RE: Recall 07E-030

Re: Atwood Mobile Products  
Part 573 Defect and Noncompliance Report – Sealed Burner Tube Recall

Re: Recall of burner tubes on Atwood Sealed Burner Appliances

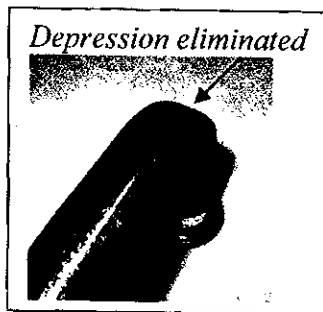
*The Range and Slide-In burner tubes leading from the gas manifold to the burner heads had a depression or 'kink' in the exterior bend restricting proper airflow and gas mixture.*

*Atwood Quality Assurance report QA7091 on March 28, 2007, revealed the following carbon monoxide levels:*

- left rear burner 1010 ppm
- right rear burner 987 ppm

*The depression or 'kink' on the exterior radius of the bend point on the burner tube is nearly eliminated.*

*Burner tube tooling was corrected by polishing the bending surfaces on April 6, 2007, along with establishing a preventative maintenance schedule for the tooling.*
